Subject: Officer South PSP and ICP

We recently received a letter from VPA dated 25.9.23 about the above and also an amendment to the Cardinia Planning Scheme.

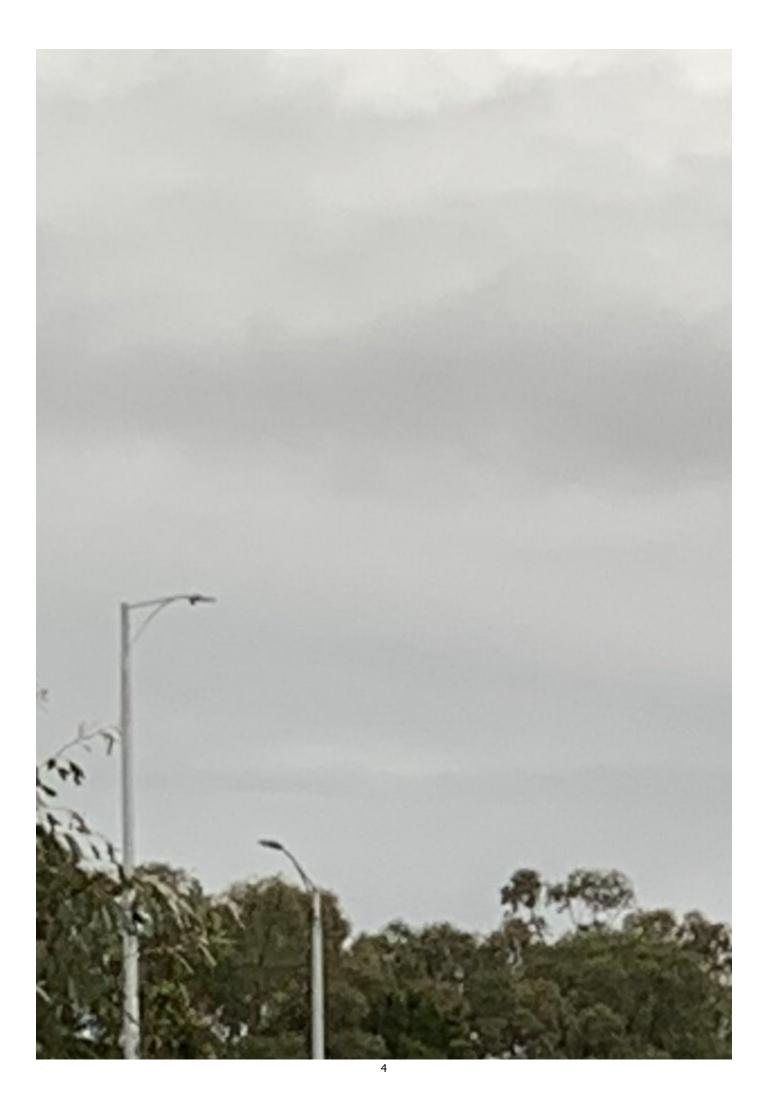
We are concerned with the proposed position of the freeway on ramp towards Warragul.

One of our concerns is regarding where the runoff of water will go from the ramp. At the moment, the Melbourne Water reserve opposite our house overflows. It flows over footpaths and across the land proposed for the freeway ramp. It has also flowed into the street, where SES & police have previously attended. I have attached photos taken this morning showing the overflow of water. We have been previously told by the council that water will flow into the area from the hills. We therefore expect the water level to continue to rise over the next day or so. Could you please advise what is proposed to prevent more runoff from the new freeway on ramp into this area? What is proposed to prevent the continuous flooding? The paths along the reserve are used by many residents for walking & cycling, and the flooding is already very frustrating.

We would also like to see a design on the proposed ramp. How close will it come to our homes? Will there be a sound barrier between our homes & the ramp? The current freeway bridge sound barrier is completely ineffective, and the increased traffic along Officer South Road is already noisy. Will there be any area left along the outside of a proposed sound wall for things for residents, like a small playground or exercise equipment? Is there any proposal for current residents to be subsidised to replace current windows to double glazed ones to assist with the noise? From the rough plan with the letter it appears this ramp will not have as much space between it and existing homes as the current working freeway off ramp does on the other side of Officer South Road. The distance appears greater on that side.
